SERVICE MANUAL

Oberheim

OB-8

First Edition
January 1983

SCHEMATIC 1679A SHEET 2

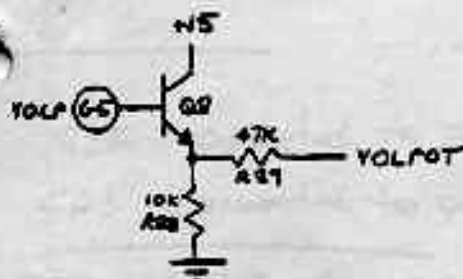
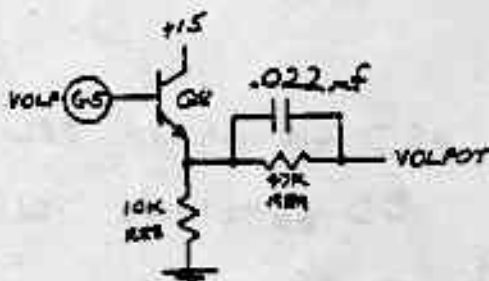
ADD .022 μ F CAPACITOR IN PARALLEL WITH R89.

TO ELIMINATE NOISE WHEN CONTROLLING THE VOLUME'S WITH AN EXTERNAL LOW IMPEDANCE VOLTAGE SOURCE.

OB-8 POT. Board 1&2 1681A

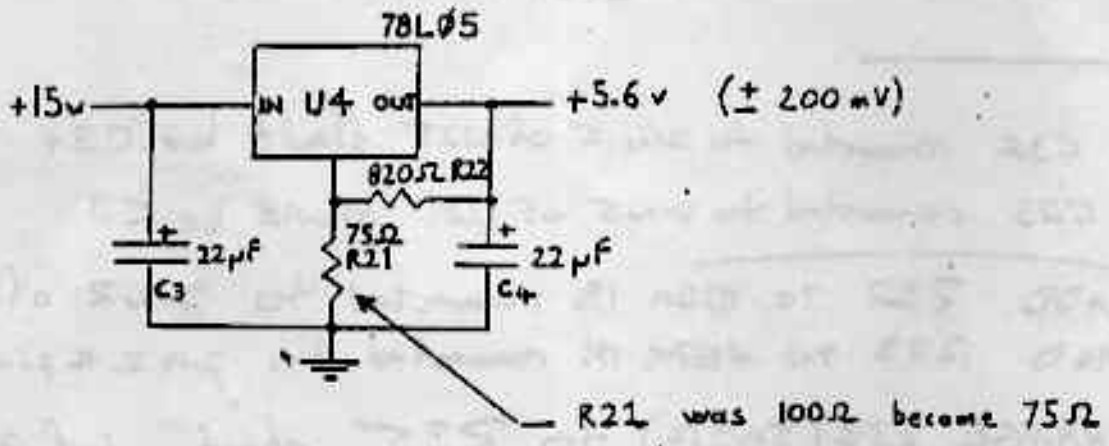
Reduce output of 5.6v Supply.

Increase the active range of the Front panel pots

OB-8 VOICE BOARD 1682A

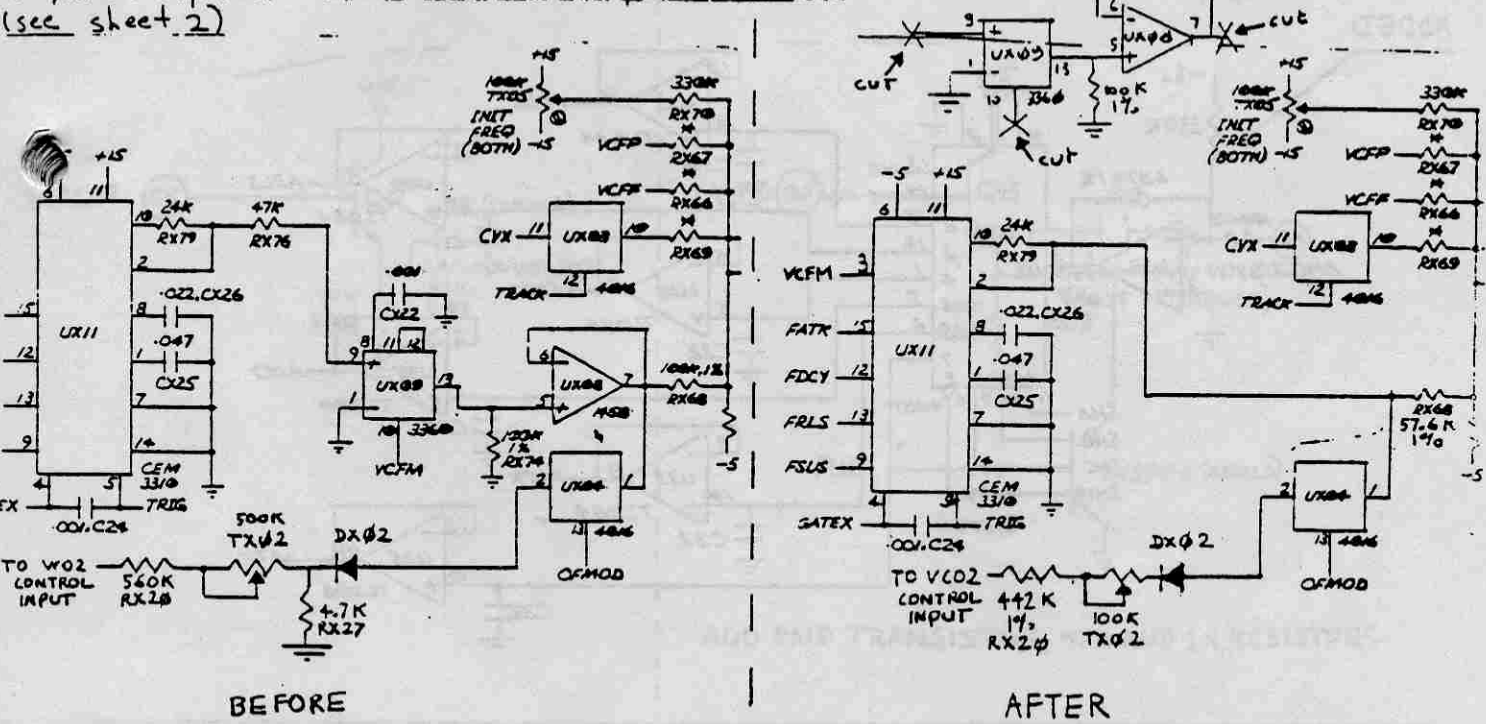
The 336 ϕ VCA is bypassed and the 331 ϕ in conjunction with the software modulates the amplitude of the envelope. A software revision A-4 or posterior must be installed.

331, at the output of U27 is short circuited. ϕ R30 is removed (see sheet 2)

Improve temperature stability and tracking of VCO2 filter env. modulation

OB-8 VOKE BOARD 1682A

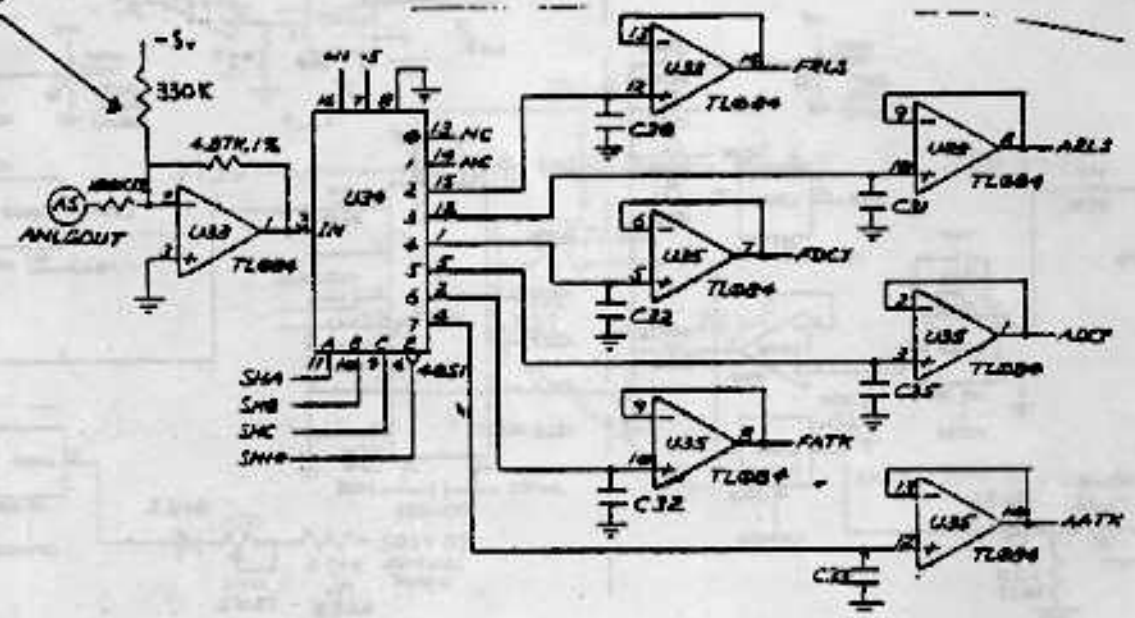
Add a resistor between -5v and pin 2 of U33 (upper & lower voice)
A software revision A-4 or posterior must be installed and the offset
calibration of the service center test must be performed.

The offset calibration routine of the service center test can correct
the TL084 for positive or negative offset.

SCHEMATIC 1679 A, SHEET 2
OB-8 PROCESSOR BOARD

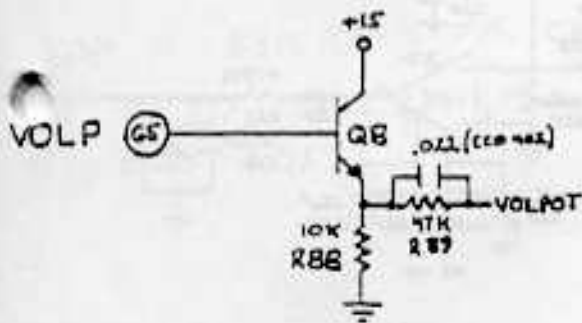
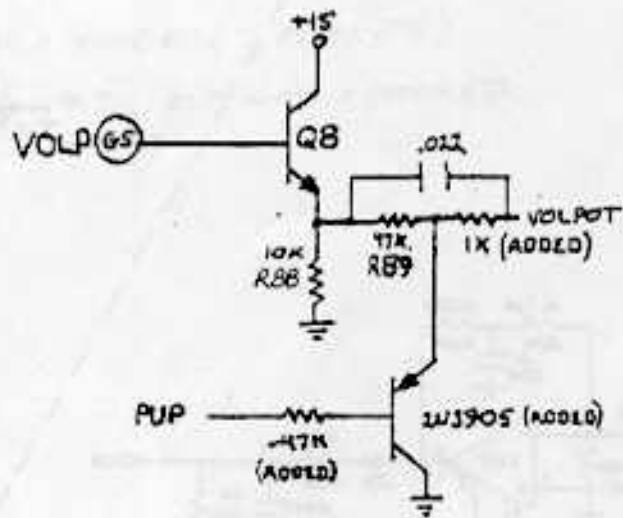
ADD PNP TRANSISTOR, 47K AND 1K RESISTORS

TO REDUCE POWER-DOWN GLITCH AT OUTPUTS

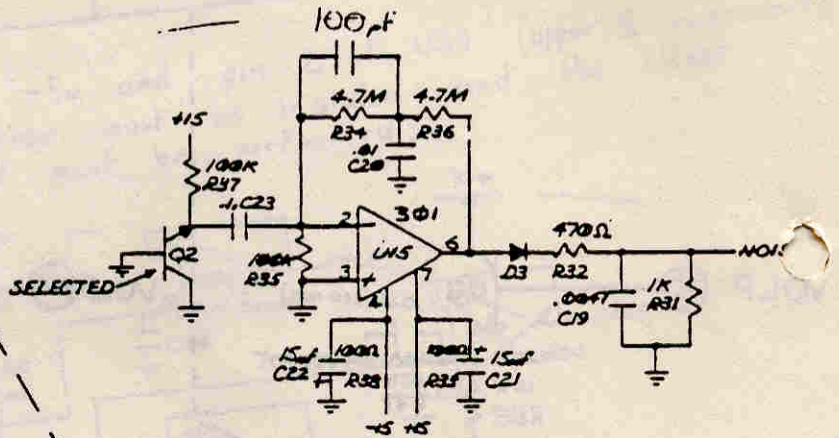
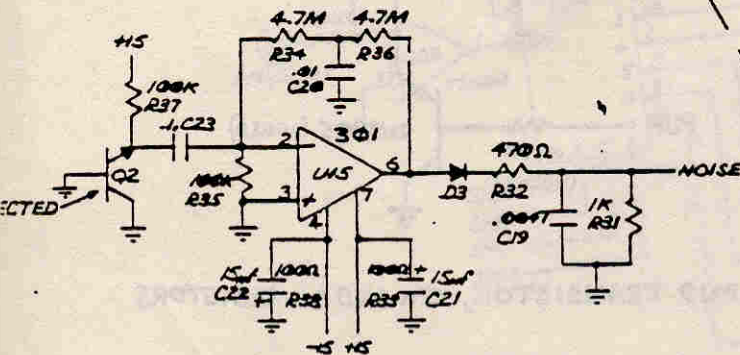
ADD A 100pF CAPACITOR
IN PARALLEL WITH R34

ON REVISION A PROCESSOR BOARDS, WHEN A SEQUENCER IS CONNECTED,
DISTORTION BECOMES PRESENT IN THE NOISE GENERATOR.

OB-8 BEND BOX 1680A SHEET 1 OF 1

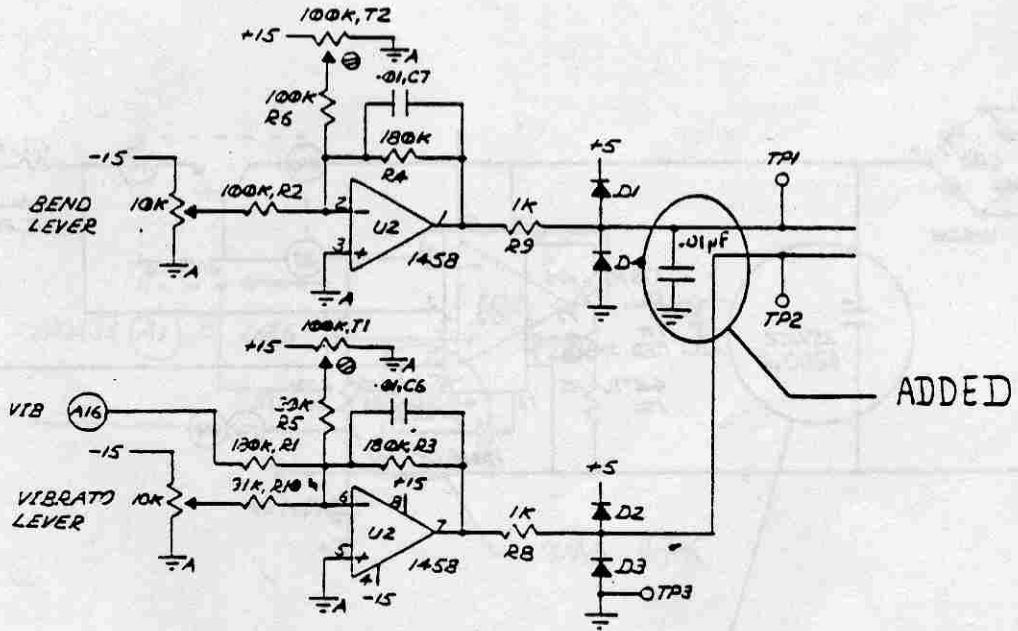
- REMOVES NOISE MODULATION FROM BENDER LEVER

PROCESSOR BOARD- POWER SUPPLY
1679A SHEET 4 of 4

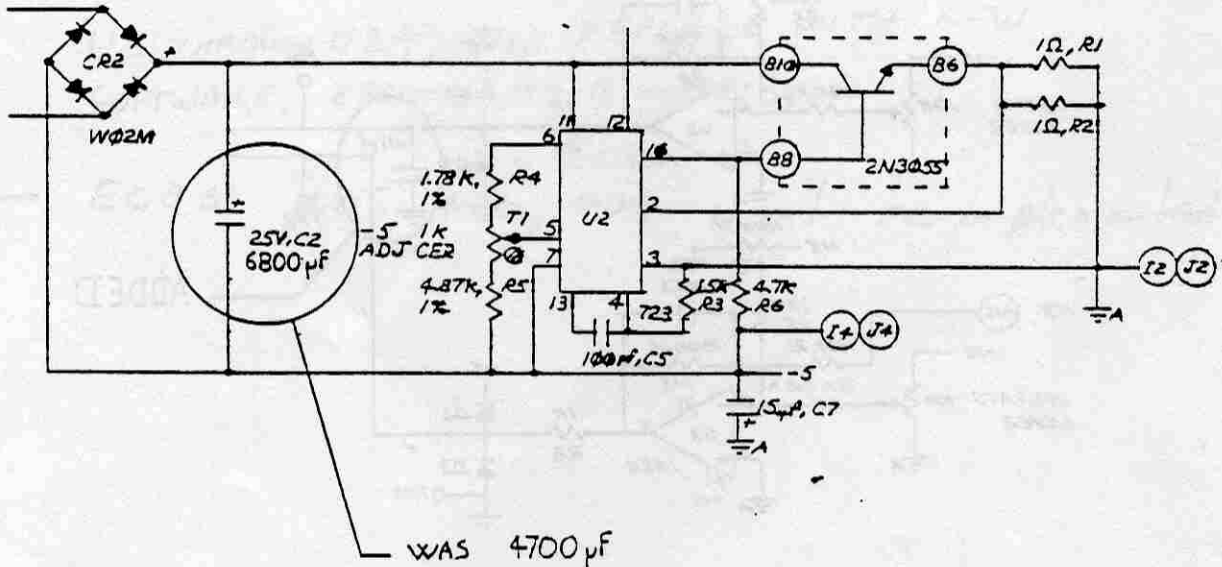
WHEN THE NEW POWER SUPPLY TRANSFORMER (REF. 561021) IS USED, THIS CHANGE DECREASES THE OUTPUT THUMP ON POWER OFF.

DRAWINGS AFFECTED
 VOICE BOARD 1682A SHEET 2 OF 3

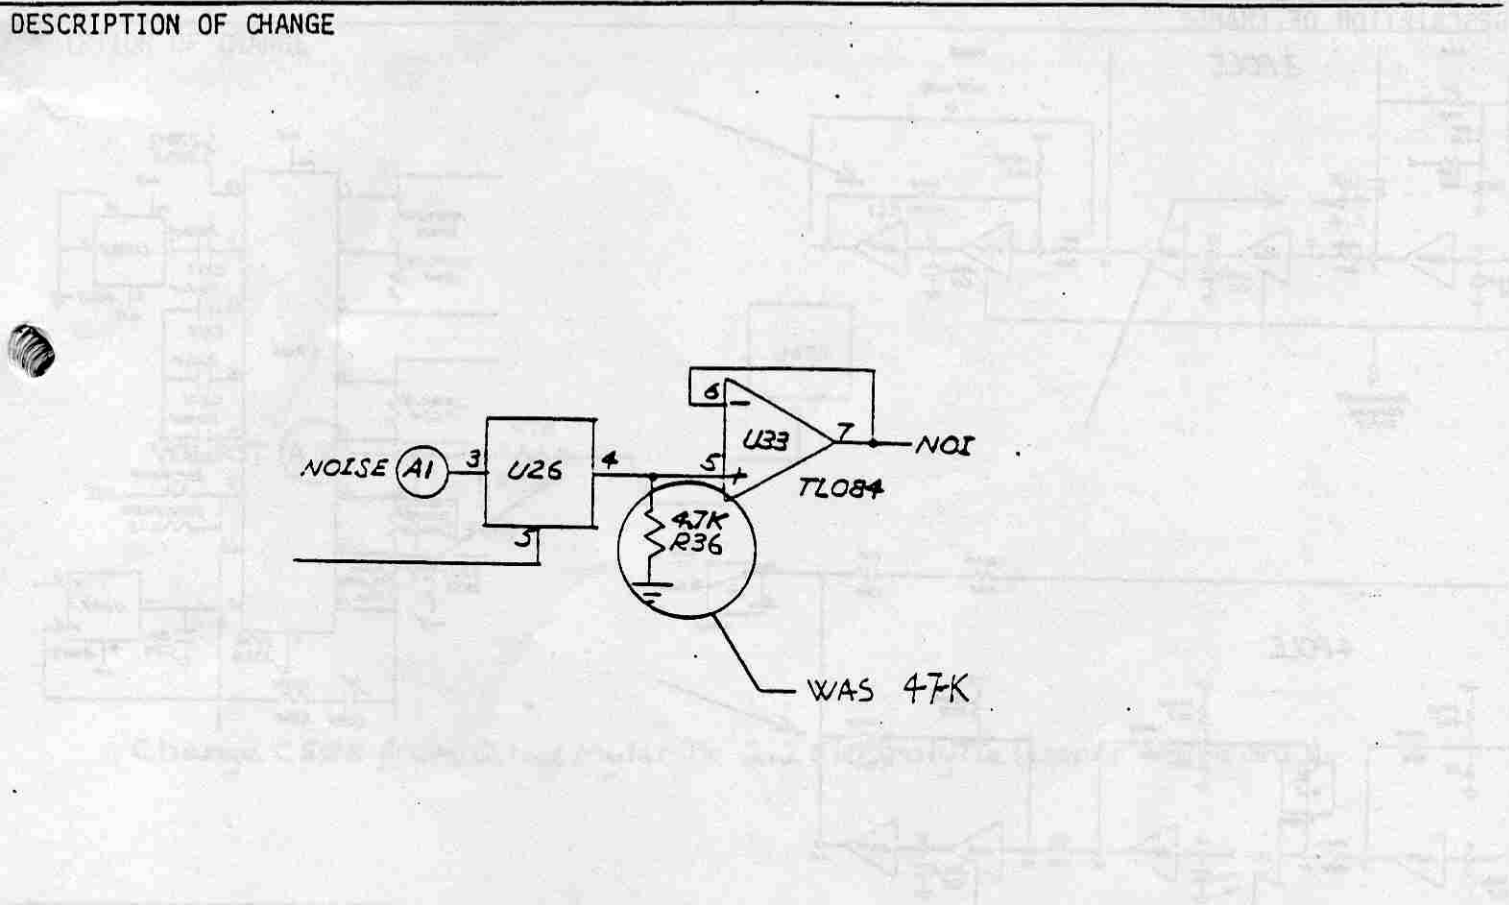
REASON FOR CHANGE
 REMOVE LEAK OF NOISE GENERATOR WHEN A VOICE IS GATED

1682A VOICE BOARD

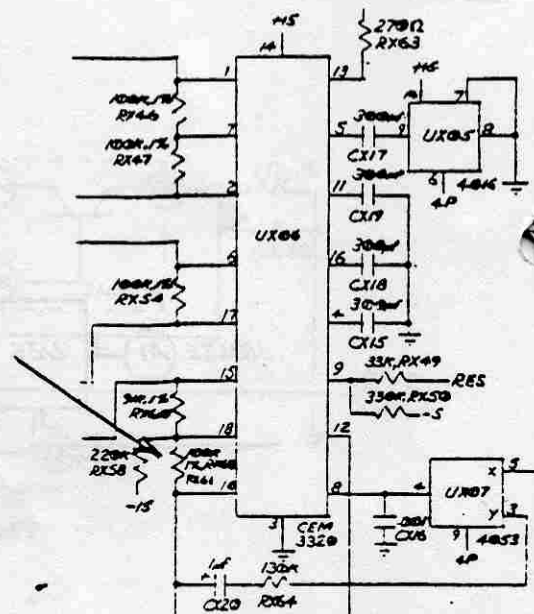
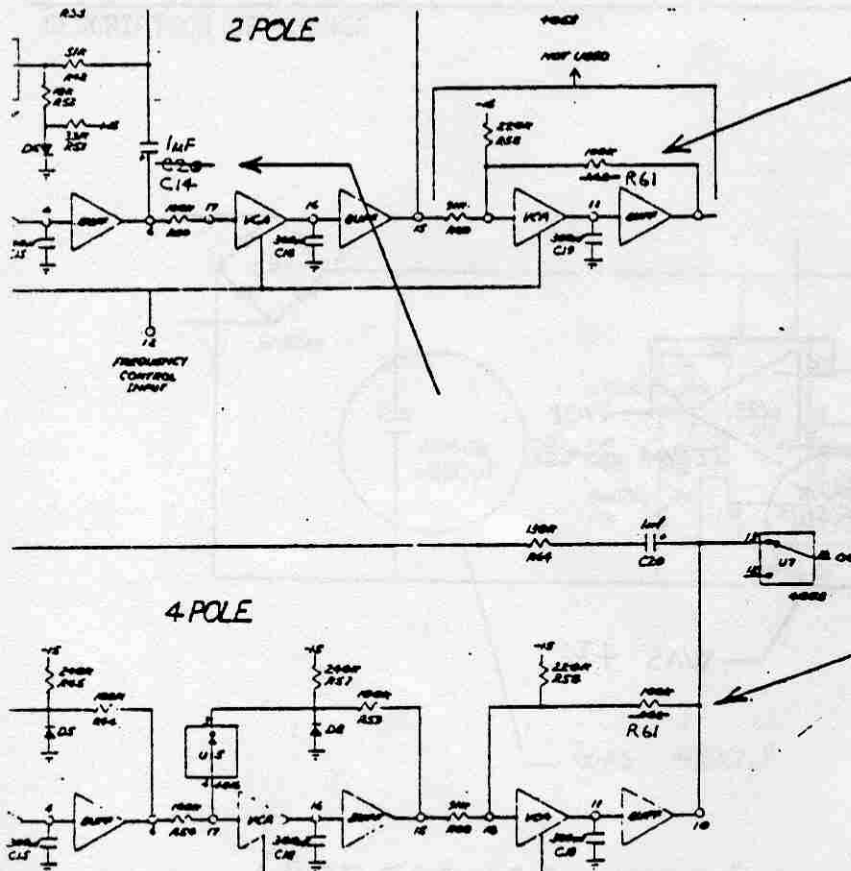
RESISTOR AT UX06 PINS 10, 18 MARKED RX68 SHOULD BE RX61.

CAPACITOR IN 2 POLE/4 POLE CONFIGURATION DRAWING MARKED C20 SHOULD BE C14.

1682 B OB-8 VOICE BOARD (UPPER)

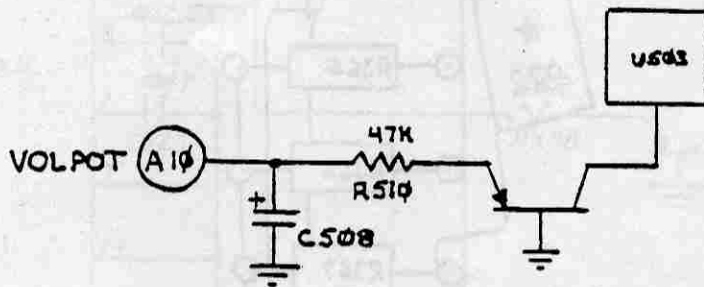
Change C508 from 0.1uf Mylar To 2.2 Electrolytic (Upper Voice only)

To eliminate noise at output at low master volume levels

1632 B OB-8 Voice Board
1689 B

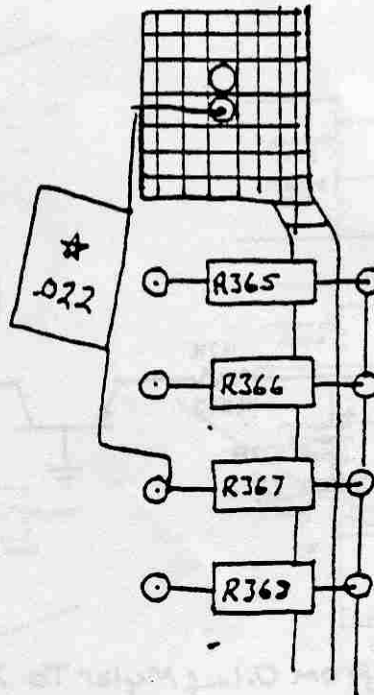
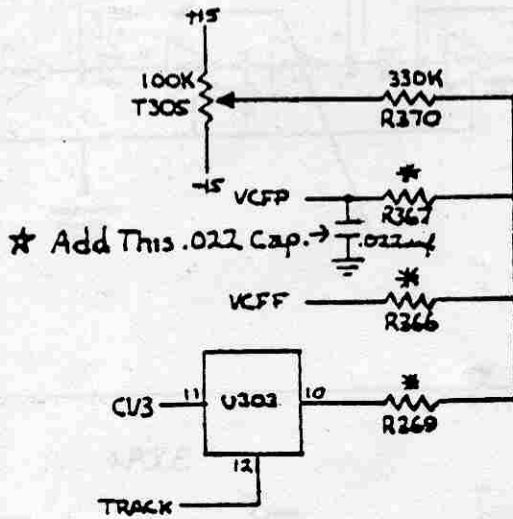
Add a .022 Mylar Capacitor To both The Top and bottom Voice Boards

To Filter-out digital noise picked up along The Filter Pedal line (VCFF) when a Sequencer (05X) is connected.

OB-8 VOICE BOARD 16.82 B SHEET 3 OF 3

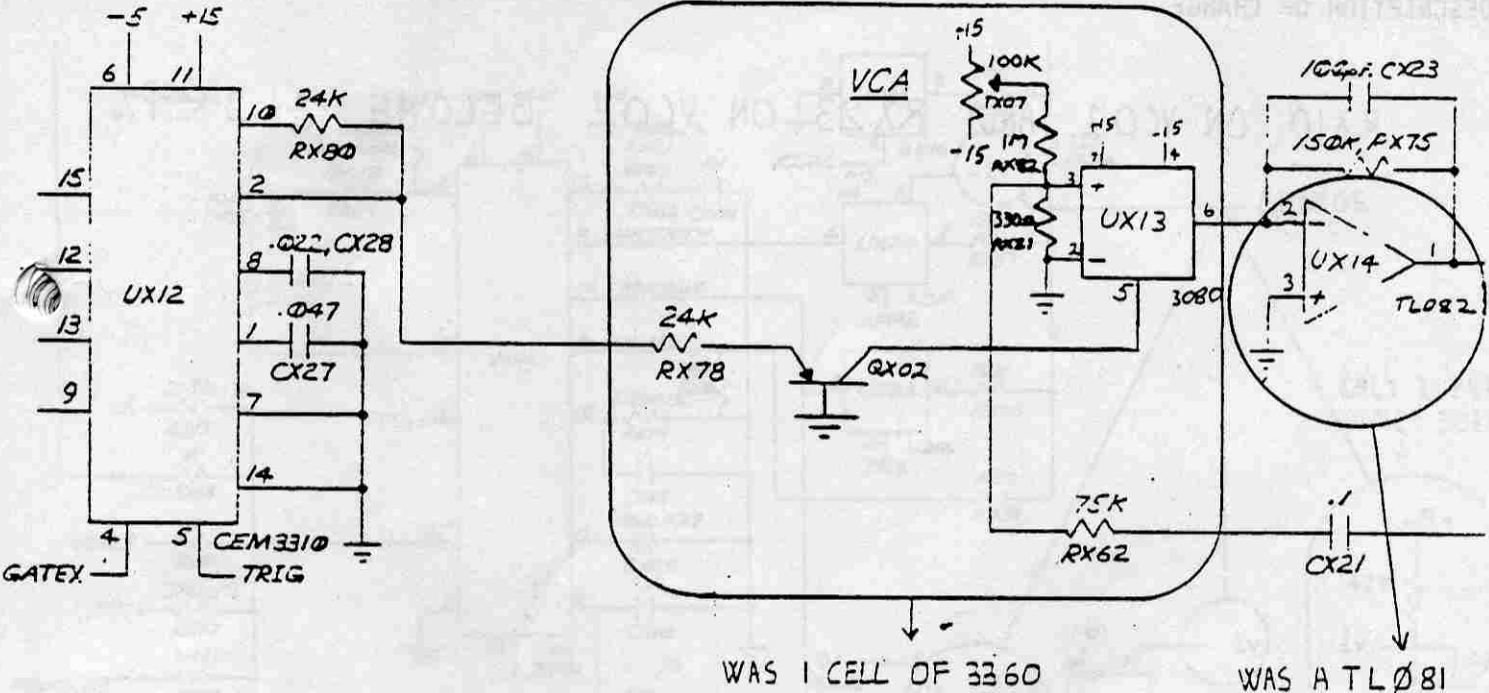
- ALSO: UX08 IS DELETED AND REPLACED BY THE OTHER CELL OF THE TL082 UX14

- RATIONALIZE THE CIRCUITRY

OB-8 VOICE BOARD 1682A SHEET 3 OF 3

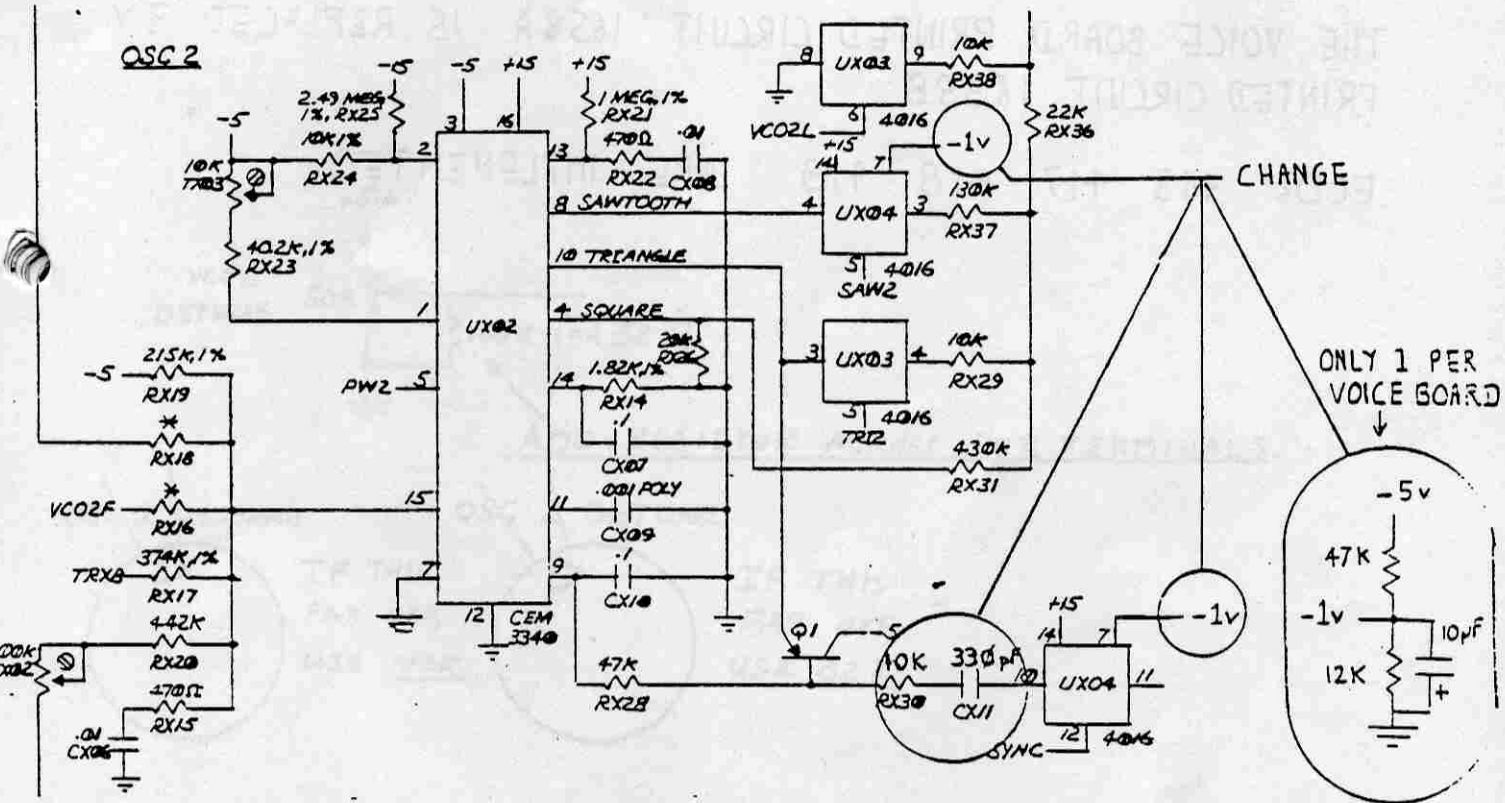
- IMPROVES SYNCHRO SOUND

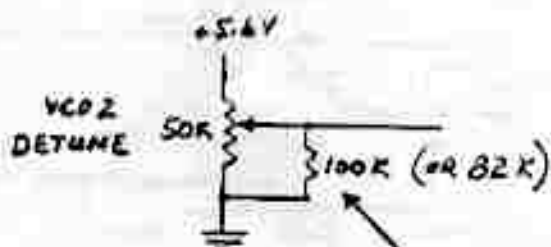
ADD RESISTOR ACROSS POT. TERMINALS.

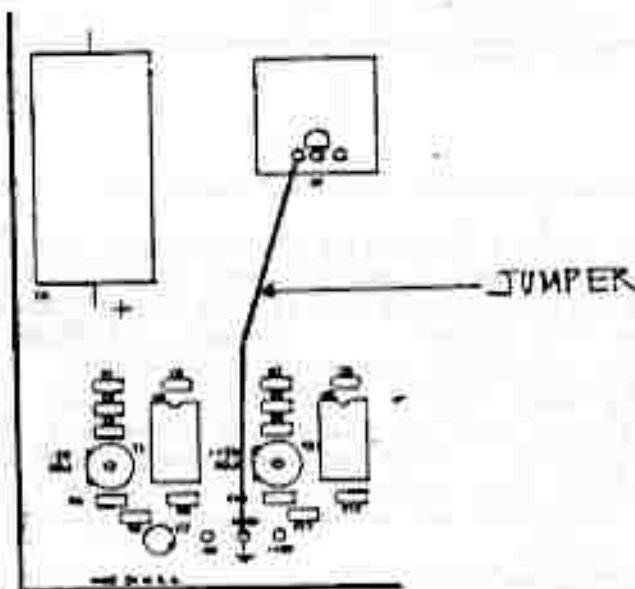
ADD A JUMPER BETWEEN PIN 1 OF THE -15 REGULATOR
7915 (GND) AND THE GROUND REFERENCE TEST POINT.
THE JUMPER MUST BE MADE OF A 18 AWG WIRE (.04 inch / 1 mm)
MINIMUM AND MUST BE SHORT.

TO REMOVE AC HUM ON AUDIO OUTPUT.
